Access Compliance Report Public Rights-of-Way (Curb Ramps)

Main Street: SALIENTE_RD		Cross Street: ALAR_ST		Location:	NW
ADA ID: RPAT211104101850	Ramp Type: Type 4 - Parallel	Initial Pass/Fail: Fail	Overall Compliance: No	Severity Score:	32
Codes/Mitigation Info/Possible Solution			Field Measurements/Component Compliance

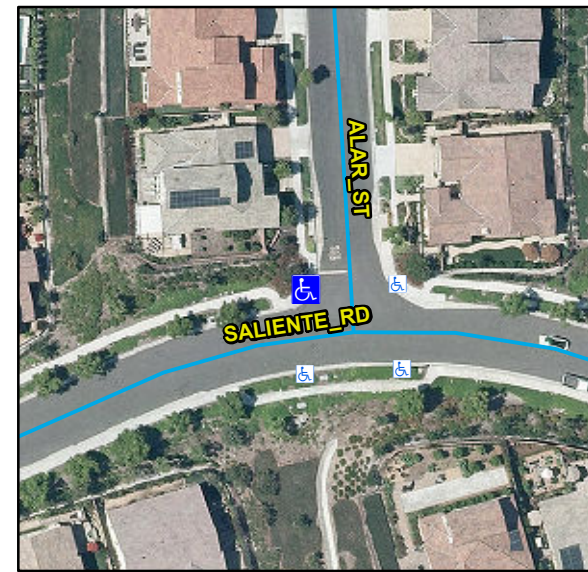
R304.5.3, R304.3.2, STD 1115

Remove & Replace Curb Ramp With Two New Directional Ramps or Equivalent.
